Docket Number:	06-AFC-09C
Project Title:	Colusa Generating Station - Compliance
TN #:	203610
Document Title:	Application for Staff Approved Project Change to Amend Docket
Description:	Fin Fan Cooler
Filer:	Charles Robert Price
Organization:	Pacific Gas & Electric Co.
Submitter Role:	Applicant
Submission Date:	2/6/2015 9:17:02 AM
Docketed Date:	2/6/2015

Subject: Petition To Amend The Commission Decision For The Colusa Generating Station.
Docket NO. 06-AFC-09

COLUSA GENERATING STATION APPLICATION FOR STAFF APPROVED PROJECT CHANGE

SCALE	DRAWING SIZE
SCALE: 1"=50'	ANSI E (44" x 34")
WORLEYPARSONS DWG. NO.	REV
COLS-1-DW-111-002-002	M

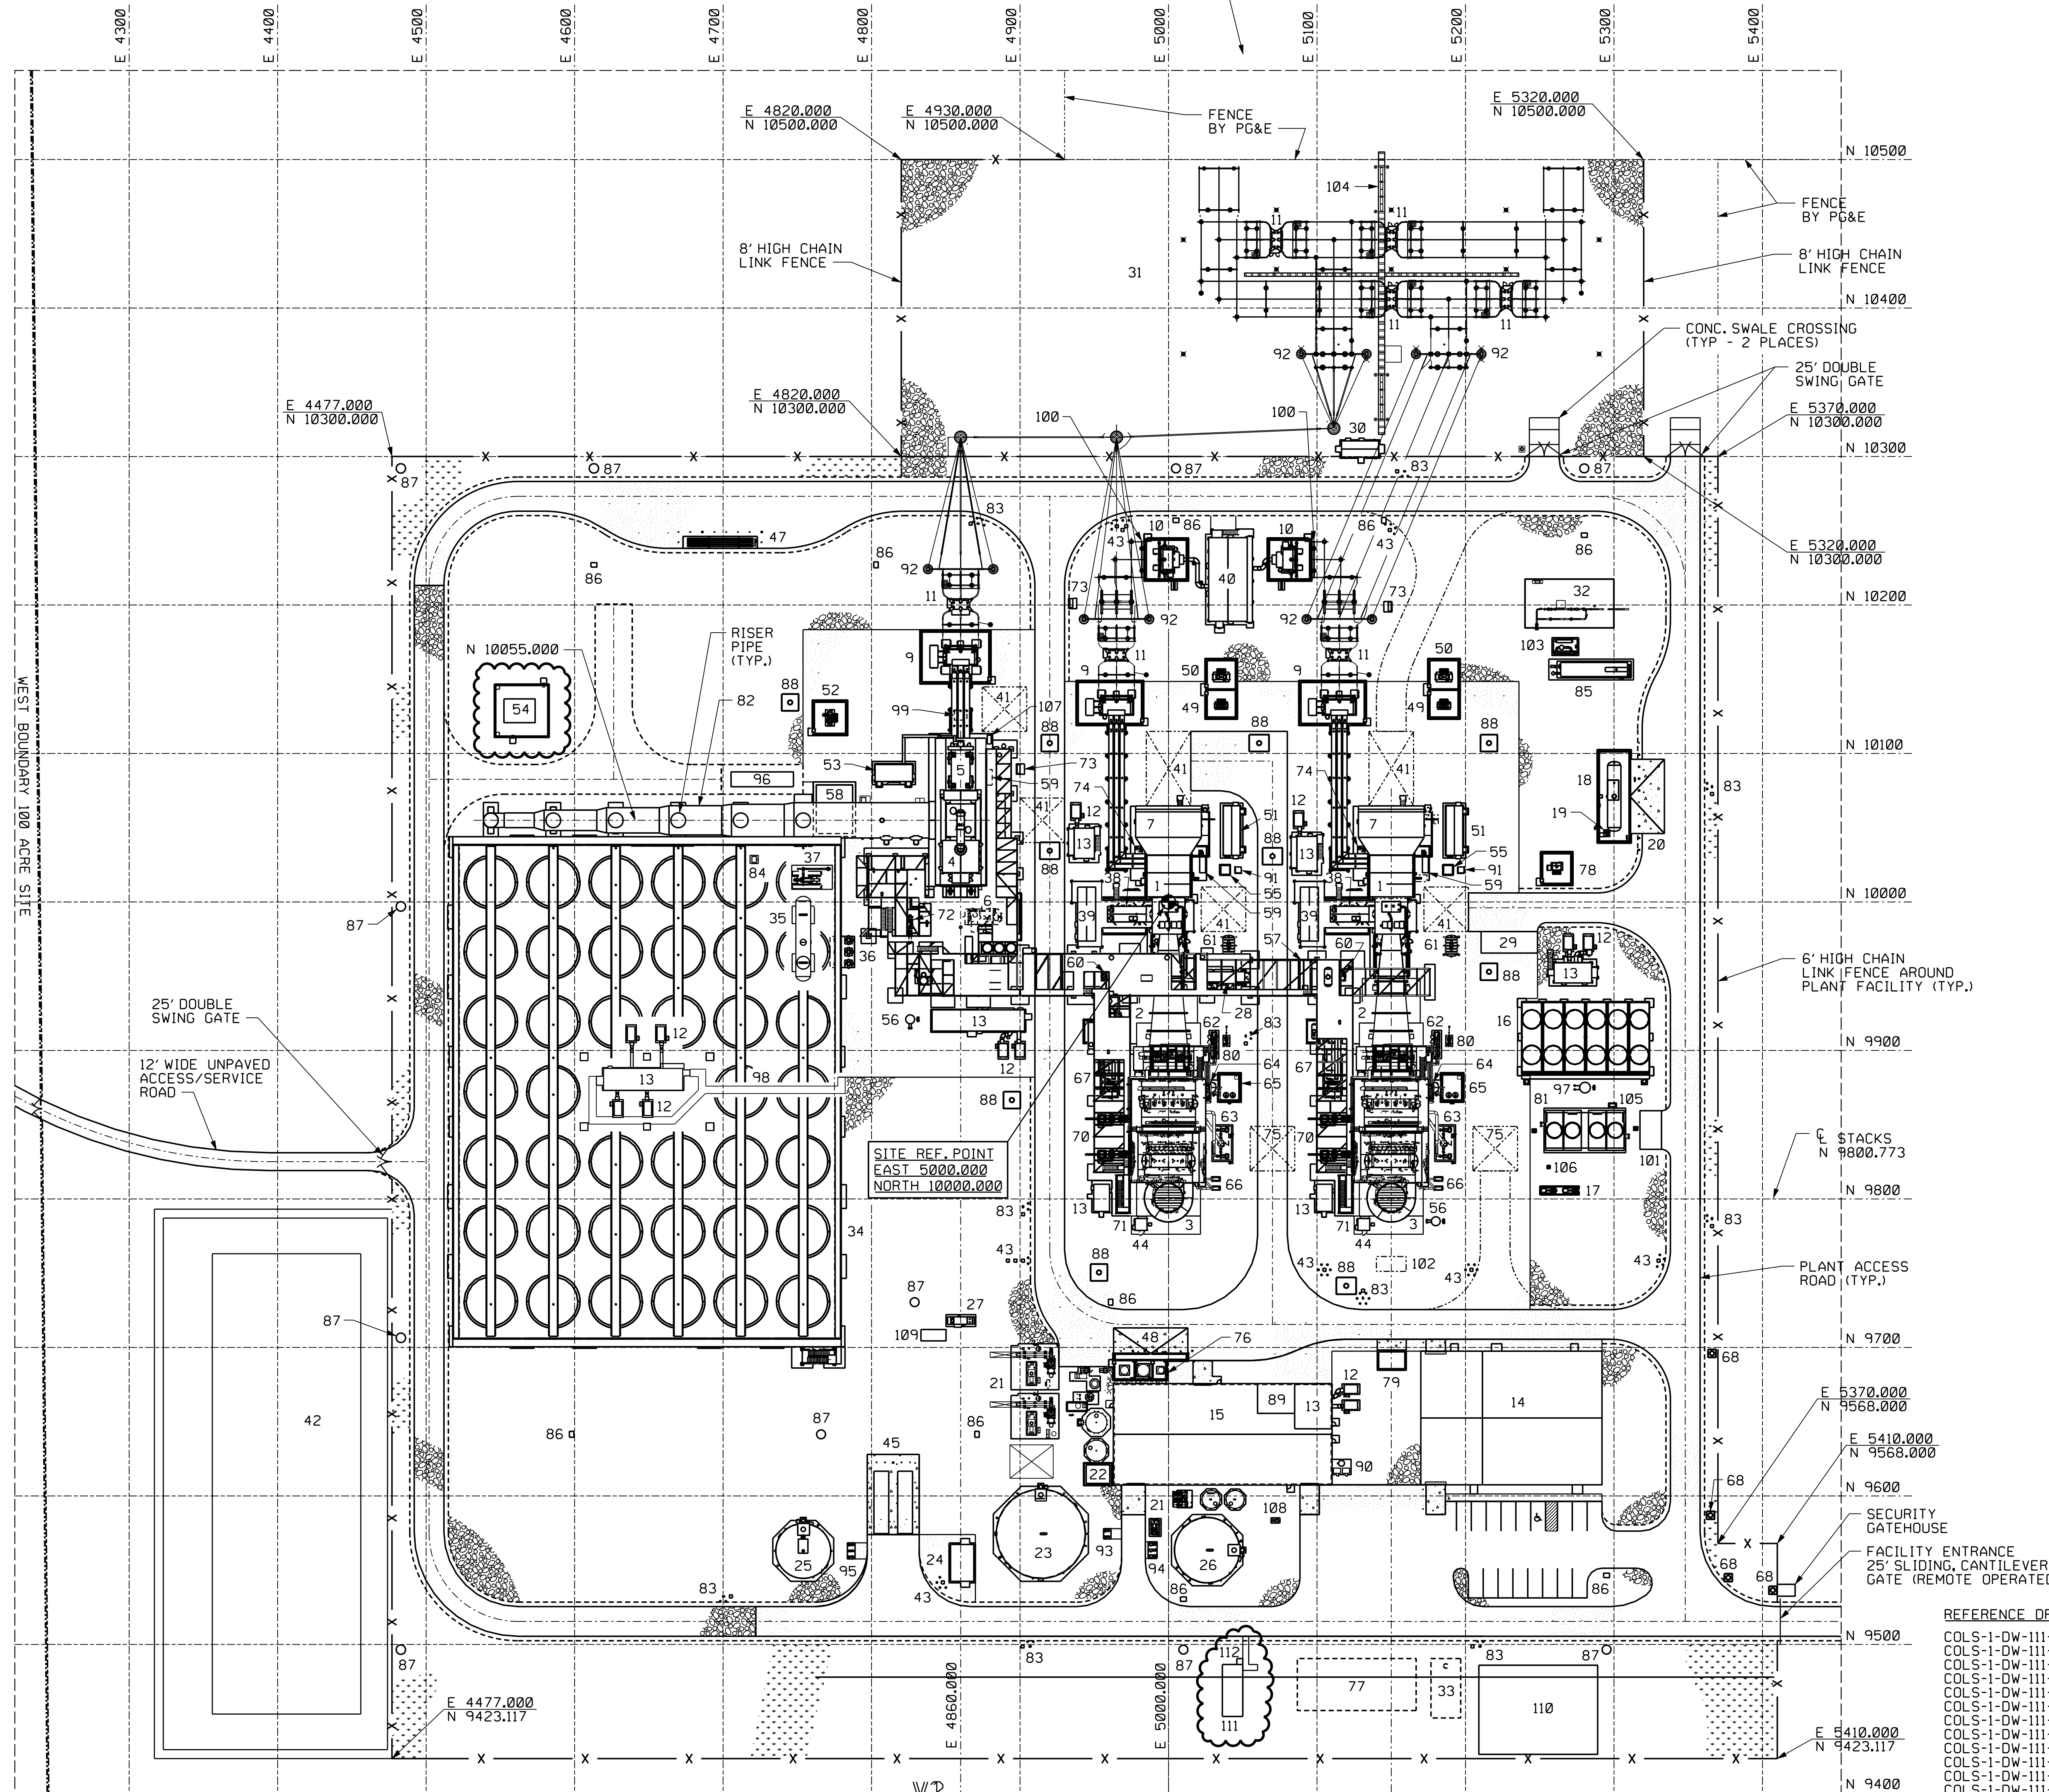
The CGS plans to add a fin fan cooling apparatus to dry cool the Heat Recovery Steam Generator (HRSG) Blowdown effluent water in order for the temperature to meet the necessary specifications to be reprocessed through the facilities Ultra Filtration system for immediate reuse as process water. Through the operation of the facility it has been determined that the attemperation of the blowdown is inadequate.

To solve the issue, a permanent system modification consisting of the addition of a two fan, single cell, fin fan air cooler, will be installed to remove sufficient heat from the HRSG effluent. The modification will include redirecting the effluent prior to the UF Feed Tank to the fin fan cooler. The effluent of the fin fan will pass directly into the UF Feed Tank at a temperature <110 F.

NO.	DESCRIPTION	APPROVED	DATE	BY	FOR
M 01/14/08	FIN FAN ADDITION	AP	SDR	MC	JO
L 03/11/08	ISSUED FOR INFORMATION ONLY	RWB		RWB	SJR
K 10/16/07	GENERAL OVERALL UPDATES FOR FINAL ISSUE	RWB		RWB	SJR
J 12/10/07	REV. ARRANGEMENT OF SOUTHWEST 80%/ZLD AREA & AS INDICATED	RWB		RWB	SJR
H 05/16/07	REVISED AS INDICATED	RWB		RWB	SJR
G 05/02/07	REVISED AS INDICATED	RWB		RWB	SJR
F 05/28/07	REVISED AS INDICATED	RWB		RWB	SJR
E 03/03/07	REVISED AS INDICATED	RWB		RWB	SJR
D 01/17/07	GENERAL UPDATES	RWB		RWB	SJR
C 02/03/07	GENERAL UPDATES	RWB		RWB	SJR
B 02/24/07	GENERAL UPDATES	RWB		RWB	SJR
A 01/14/08	INITIAL PROGRESS ISSUE	RWB		RWB	SJR

COLUSA GENERATING STATION
 EQUIPMENT SETTING PLAN
 HRSG BLOWDOWN FIN FAN COOLER EQUIPMENT PLAN
 SCALE: 1/8" = 1'-0" ANSI E (44" x 34")
 DRAWING NO.: COLS-1-DW-111-012-907
 REV: A

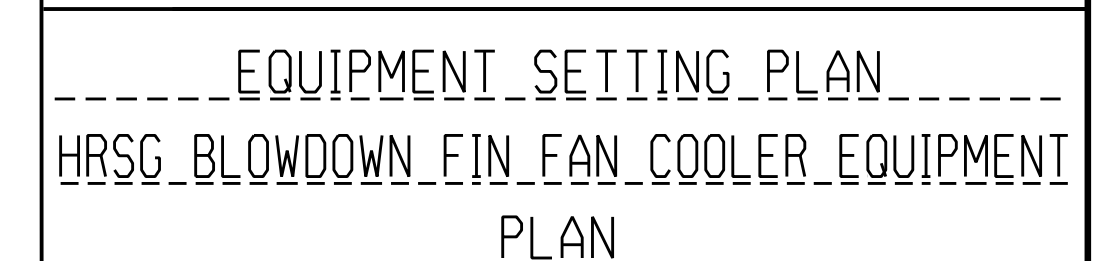
The CGS plans to install dry cooling equipment, specifically fin fan units, to reduce the temperature of effluent water from the Heat Recovery Steam Generating (HRSG) unit blowdown tanks.
